**SUBJECT: TOPAZ3, L.L.C.
FCC ID: O7KPL150
731 Confirmation No.: EA102136
Correspondence Ref. No.: 21028**

On behalf of Topaz3, L.L.C. we hereby submit our response to your e-mail dated October 23, 2001 requesting additional information for the subject application.

Phantom Measurement Points & EUT Positioning

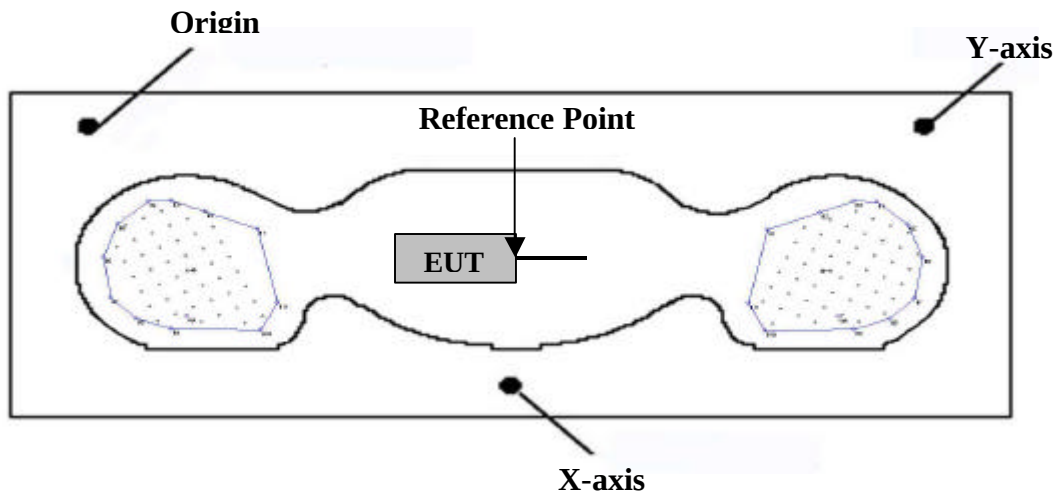
2. The depth of the simulating tissue in the planar area of the Generic Twin phantom used in the SAR evaluation is no less than 15.0cm.
3. Please see attached sketch showing the positioning of the EUT in reference to the phantom reference points.
